SUPPLEMENTAL FINAL ENVIRONMENTAL
IMPACT STATEMENT

ALBANY PORT DISTRICT COMMISSION
PORT OF ALBANY EXPANSION PROJECT

TOWN OF BETHLEHEM, NEW YORK

Date: February 2022

Figure 2.3-1:

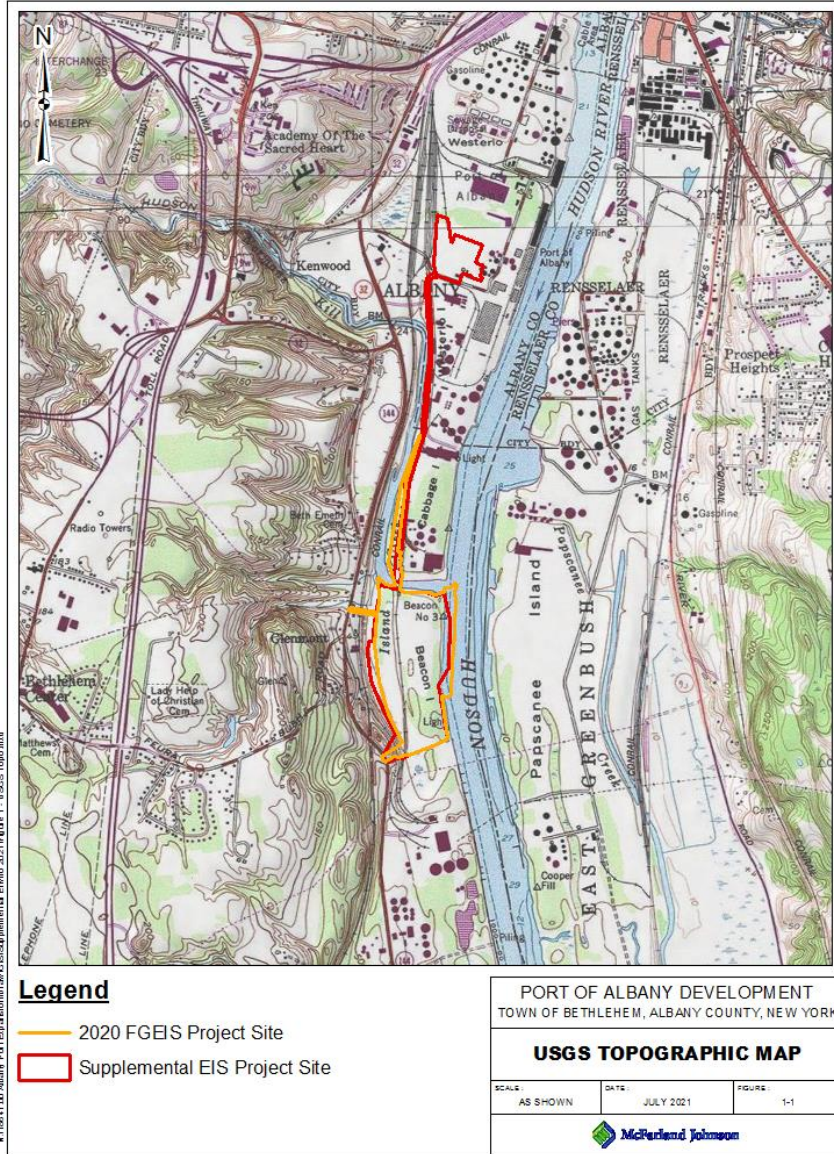
Comment A-3: Figure 2.3-1, and similar figures throughout the SDEIS, are confusing, especially where the 2020 Final GEIS Project Site line and Supplemental EIS Project Site line are depicted within the Hudson River. Based on the figure, it appears that the Supplemental EIS Project Site includes some but not all the area in the Hudson River, however, the SDEIS includes statements like, “supplemental Project Areas do not include any lands under water” and “the supplemental Project Area is not located within or adjacent to the Hudson River.” These discrepancies should be clarified in the Supplemental Final Environmental Impact Statement (SFEIS), including updated figures, if necessary.

Figure 3.20-1 Potential Environmental Justice Areas in the City of Albany (South)

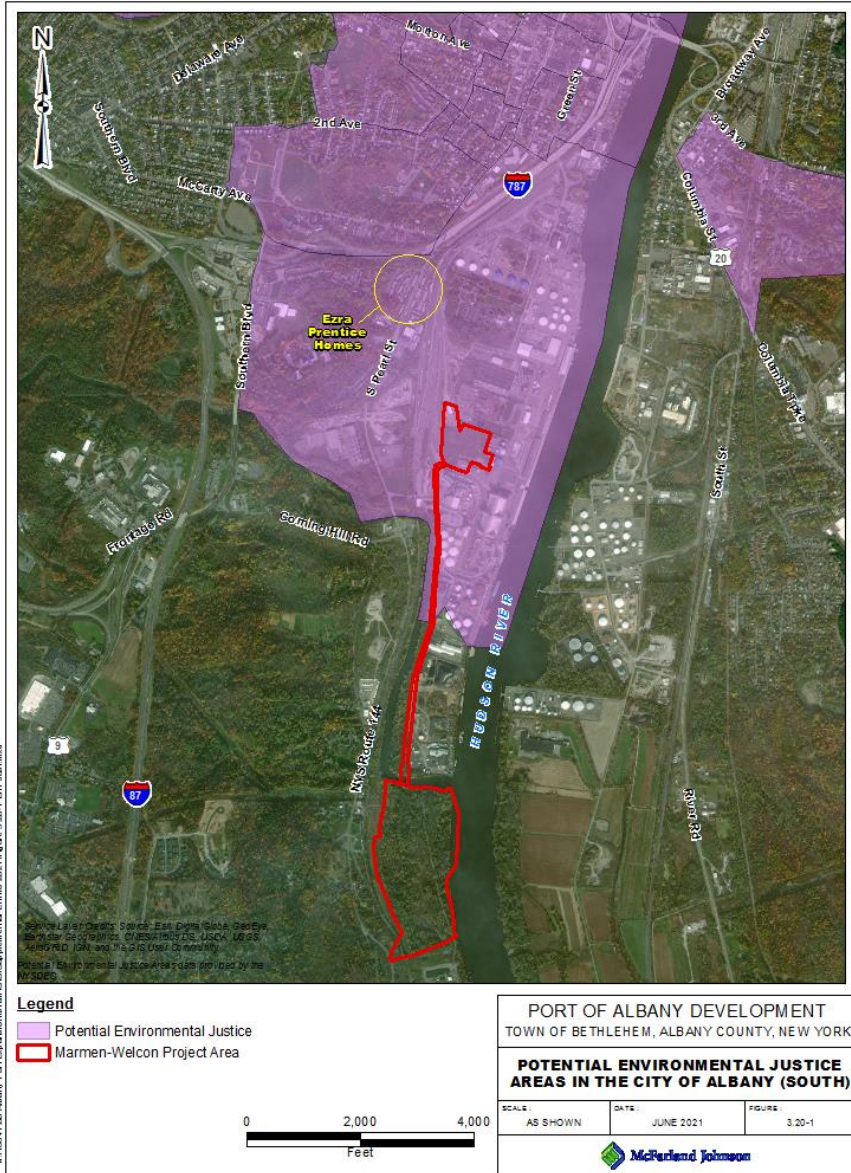
Comment A-1.15 and A-1.16: (Page 18 and Page 20) The Potential Environmental Justice Area (PEJA) Maps should be used. The PEJA area includes Ezra Prentice and extends south of it. The PDF – Supplemental EIS 2021 –10–27-4 final displays the PEJA map in Figure 3.20-1.

Figure 1.4.6-1: AERMOD 5 km Modeling Domain and Receptor Grid (Including 17 Discrete Receptors Representing Ezra Prentice)

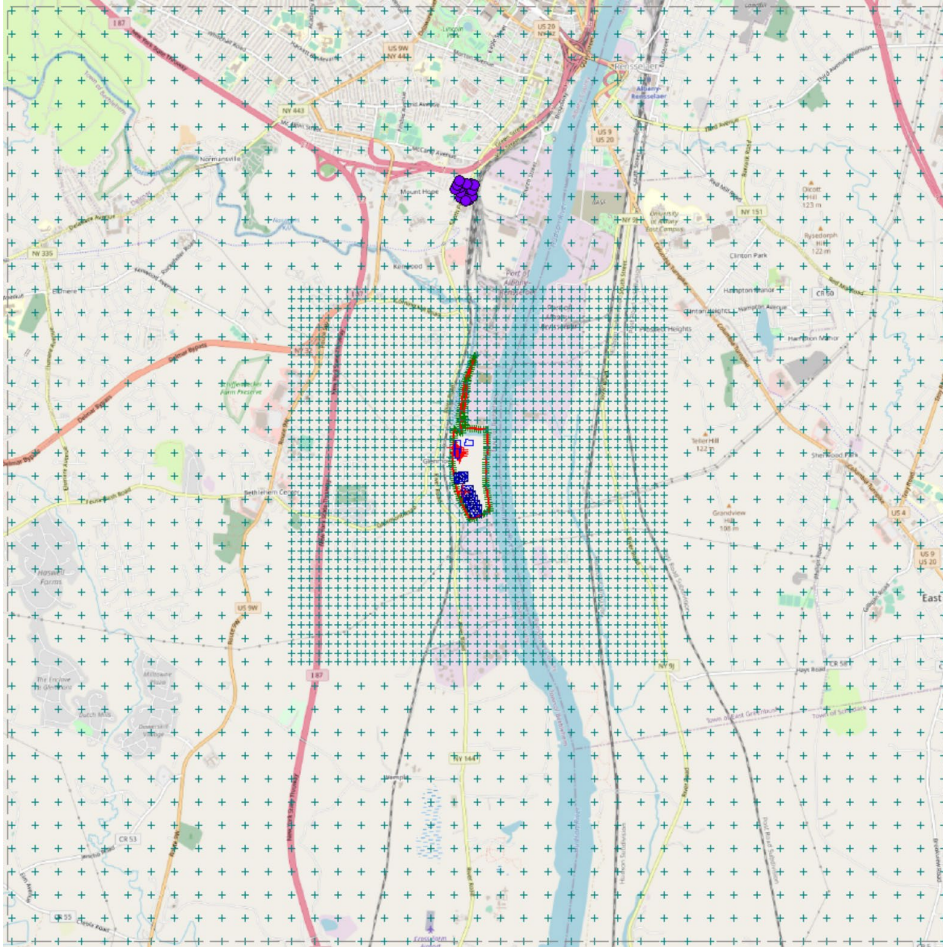
Commented [NYSDEC15]: When the air application is submitted, it must include a protocol outlining the steps taken to model offsite concentrations if AERMOD is going to be applied. The protocol should include the details of the criteria pollutant modeling in addition to the non-criteria. If AERMOD is to be used, the protocol needs approval by NYSDEC before the modeling details are submitted.

Figure 1.4.6-2: Location of EJ Area (Ezra Prentice) Relative to the Project

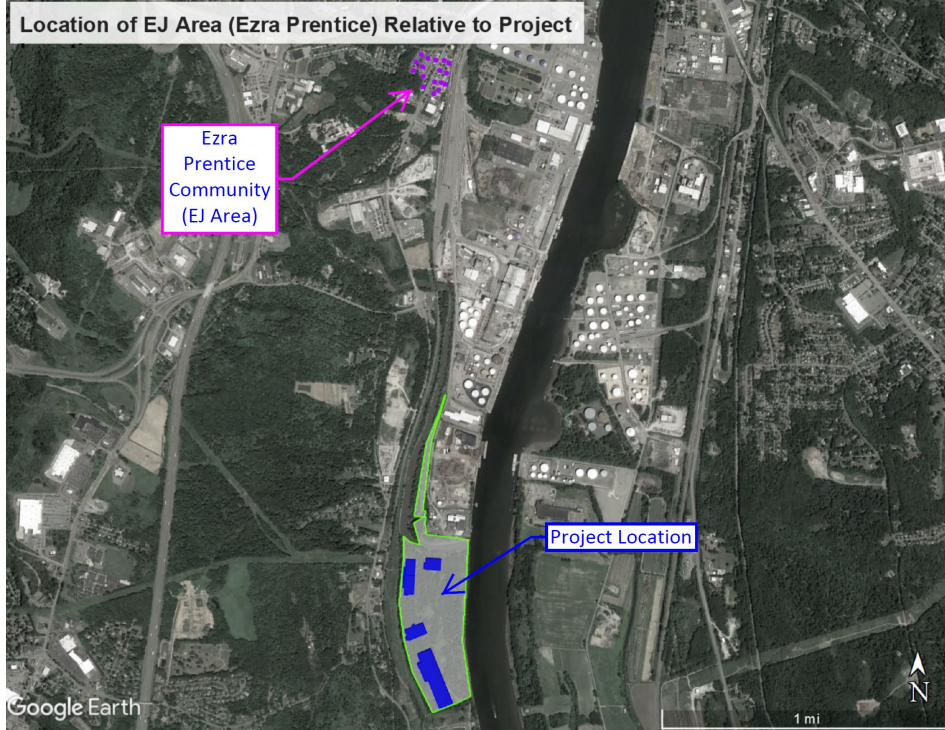
Commented [NYSDEC17]: The Potential Environmental Justice Area (PEJA) Maps should be used. The PEJA area includes Ezra Prentice and extends south of it. The PDF – Supplemental EIS 2021 –10–27-4 final displays the PEJA map in Figure 3.20-1.
